Informal document **GRSG-108-46-Rev.2**  
(108<sup>th</sup> GRSG, 4-8 May 2015,  
agenda item 5)

## **Proposal for a draft Supplement to the 04 series of amendments to Regulation No. 46 (Devices for indirect vision)**

### **Submitted by the expert from the Netherlands**

Figure 4  
**Field of vision of Class I mirror Class I field of vision**

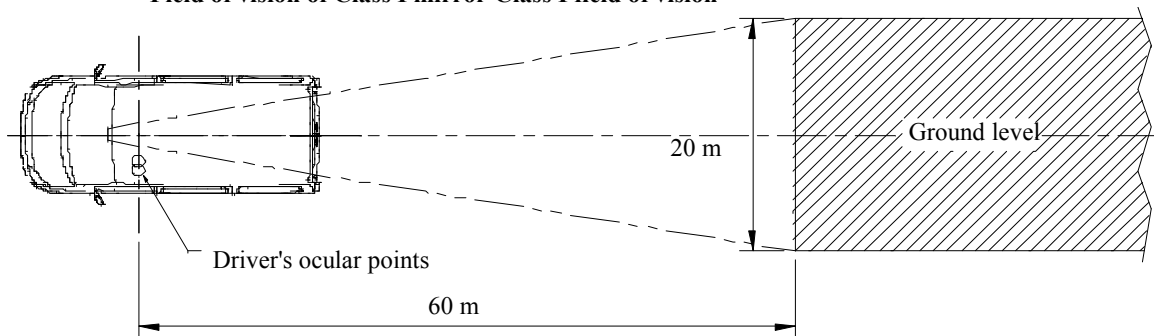
- 15.2.4. Fields of vision
  - 15.2.4.1. ~~Interior rear view mirror (Class I)~~ **Class I rear-view device**  
 The field of vision shall be such that the driver can see at least a 20 m wide, flat, horizontal portion of the road centred on the vertical longitudinal median plane of the vehicle and extending from 60 m behind the driver's ocular points (Figure 4) to the horizon.

Figure 7  
**Field of vision of Class IV wide-angle mirrors Class IV fields of vision**

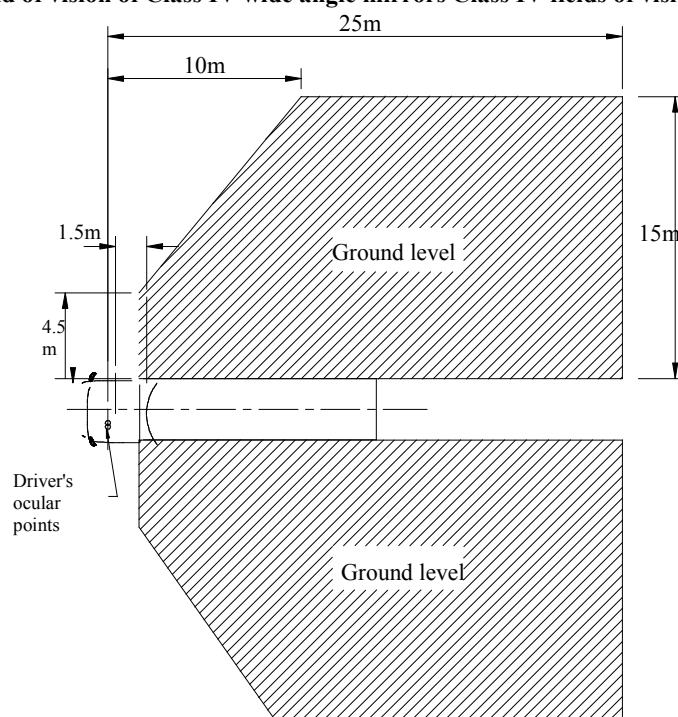
53. Paragraphs 15.2.3.1. and 15.2.3.2.  
These paragraphs specify that the provisions on adjustment apply only to mirrors.
54. Paragraph 15.2.4.4.2.  
Figure 7 has been corrected on the passenger's side so that the indicated dimensions are in correspondence with the front of the grey area.
